Enclosure 2

TMI-1 Technical Specification Revised Pages for LCA No. 287

Certificate of Service for  
TMI-1 License Change Application No. 287

**FIGURE 3.3.1**  
**Makeup Tank Pressure vs Level Limits**  
**(Instrument Error NOT Included)**

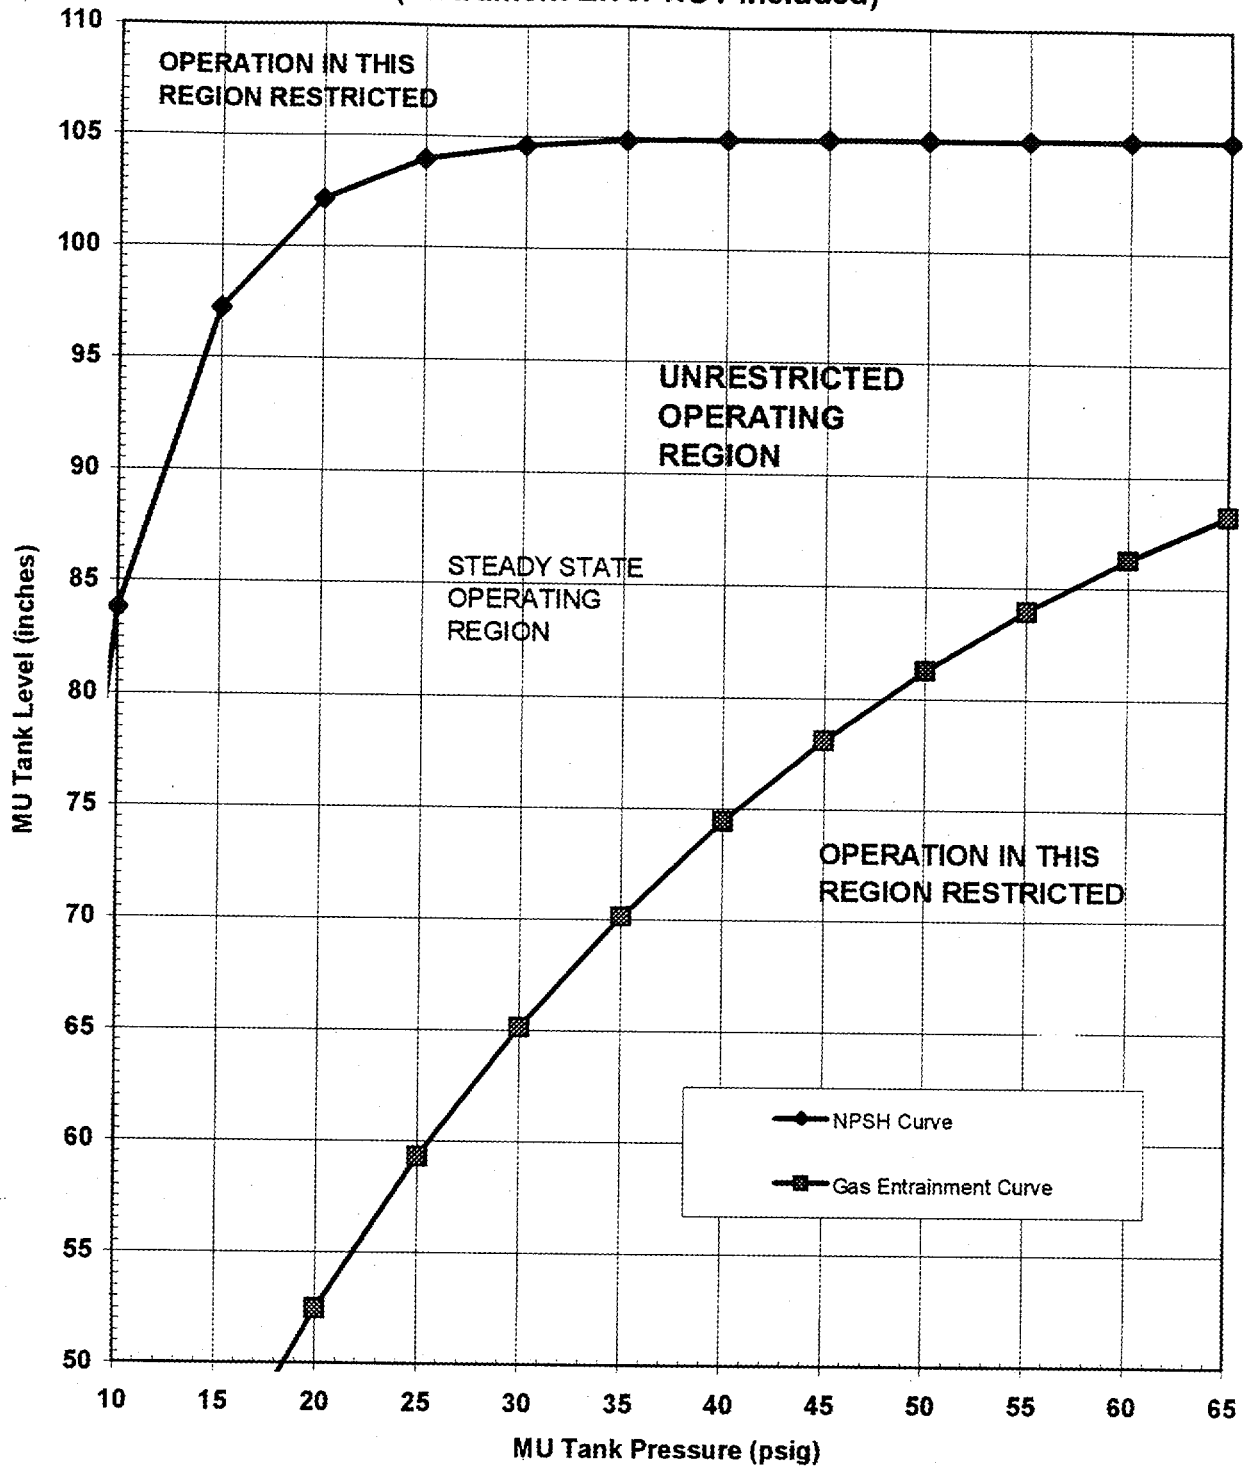
- g. **MU Tank (MUT) pressure and level shall be maintained within the Unrestricted Operating Region of Figure 3.3.1. With MUT conditions in the Restricted Region of Figure 3.3.1, restore MUT pressure and level to within the Unrestricted Operating Region within 4 hrs. Specification 3.0.1 applies.**

**Maintaining MUT pressure and level within the limits of Fig 3.3.1 ensures that MUT gas will not be drawn into the pumps and the pumps will have adequate net positive suction head (NPSH) for any design basis accident. Preventing gas entrainment of the pumps is not dependent upon operator actions after the event occurs. The NPSH limit is necessary only to preclude damage to an HPI pump if it is started prior to an ES Actuation. The plant operating limits (alarms and procedures) will include margins to account for instrument error.**

FIGURE 3.3.1  
Makeup Tank Pressure vs Level Limits  
(Instrument Error NOT Included)

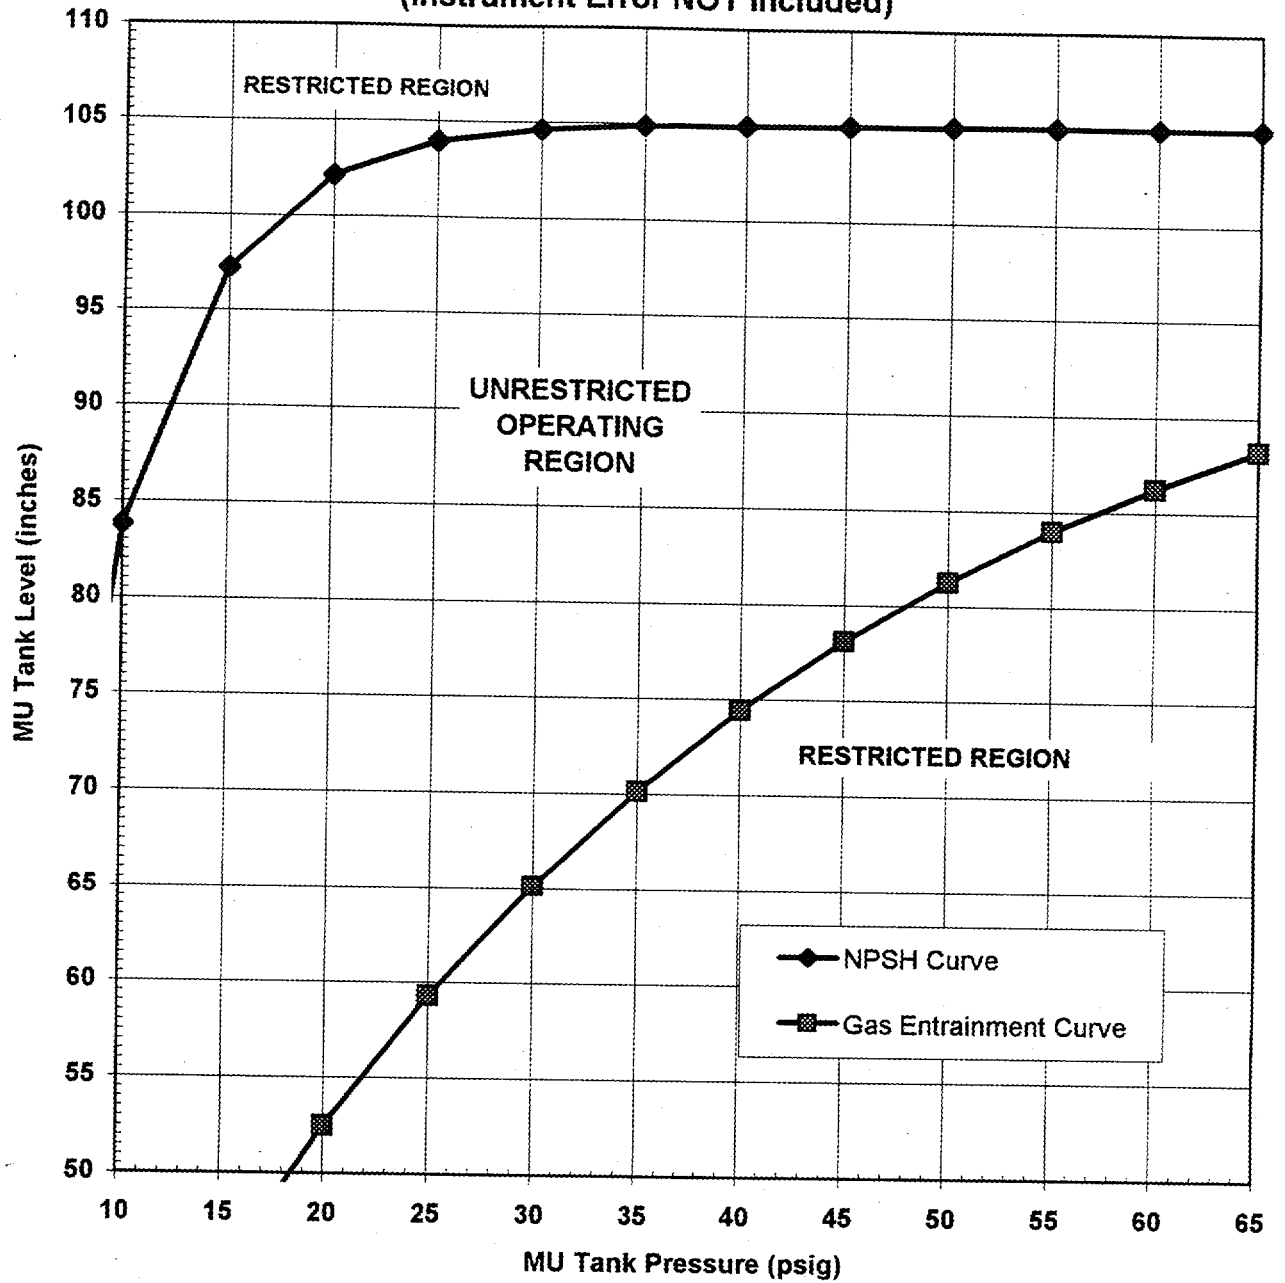
**MU Tank (MUT) pressure and level shall be maintained within the Unrestricted Operating Region of Figure 3.3.1. With MUT conditions in the Restricted Region of Figure 3.3.1, restore MUT pressure and level to within the Unrestricted Operating Region within 4 hrs. Specification 3.0.1 applies.**

**Maintaining MUT pressure and level within the limits of Fig 3.3.1 ensures that MUT gas will not be drawn into the pumps and the pumps will have adequate net positive suction head (NPSH) for any design basis accident. Preventing gas entrainment of the pumps is not dependent upon operator actions after the event occurs. The NPSH limit is necessary only to preclude damage to an HPI pump if it is started prior to an ES Actuation. The plant operating limits (alarms and procedures) will include margins to account for instrument error.**
